GEN-2016-128

Impact Restudy for Generator Modification (POI Change)

Published February 2019

Figure 1 - Woodring 345kV Substation Before POI Modification

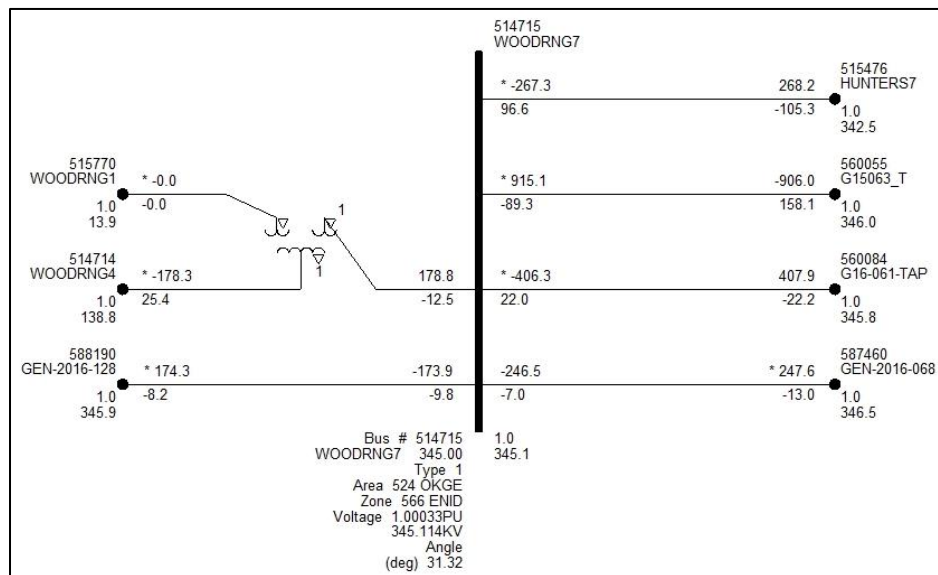
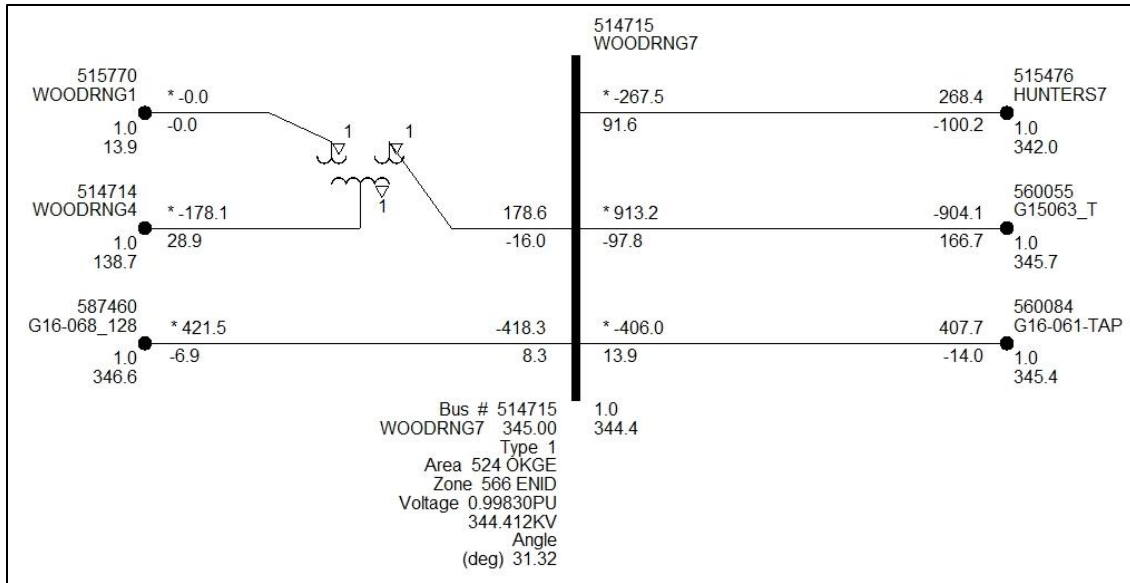
In order to verify that the change in POI from the Woodring 345kV substation to the GEN-2016-068 interconnection tie line to Woodring 345kV substation does not constitute a material modification, the POI for GEN-2016-128 was revised in the models and the local real and reactive power flows observed at the Woodring 345kV substation. The power flows from the DISIS-2016-002 Group 8 21SP Transfer Case are shown in Figure 1. Once the modification was made in the models, the power flows from the DISIS-2016-002 Group 8 21SP Transfer Case were observed and are shown in Figure 2.

As shown in Figures 1 and 2, the total real power export from the Woodring 345kV substation before the GEN-2016-128 POI change is 1,093.9 MW. The total real power export from the Woodring 345kV substation after the GEN-2016-128 POI change is 1,091.8 MW. Due to the fact that the total MW change is less than 0.2% of the total MW export from the Woodring 345kV substation, a steady-state thermal and voltage analysis was not conducted for this POI modification. The previous steady-state analysis results of the DISIS-2016-002 Group 8 impact study are still valid. Likewise, since there was no change in the collector system impedances, wind turbine generators, and very small changes to the interconnection tie line impedance and reactive power flow, a dynamic stability analysis was not conducted for this POI modification. The previous dynamic stability analysis results of the DISIS-2016-002 Group 8 impact study are still valid.

To prevent reactive power injection into the transmission system during low/no wind operation on the shared interconnection tie line for GEN-2016-068 and GEN-2016-128, approximately 40.9 Mvar of total shunt reactors to be located on the shared 345 kV bus(es) of the Interconnection Customer’s facilities. GEN-2016-128 only requires 6.2 Mvar of shunt reactor on the 345 kV bus(es), while GEN-2016-068 requires 34.7 Mvar of shunt reactor on the 345 kV bus(es). The Interconnection Customer may also install and utilize an equivalent means of compensating for the injection of reactive power into the transmission system at the Point of Interconnection.

With the assumptions outlined in this report and with all the required network upgrades in place, GEN-2016-128 with 88 GE 2.0 MW wind turbine generators should be able to interconnect reliably to the SPP transmission grid. This restudy confirms that the requested modification to change the GEN-2016-128 POI from the Woodring 345kV substation to the GEN-2016-068 interconnection tie line is not considered Material.
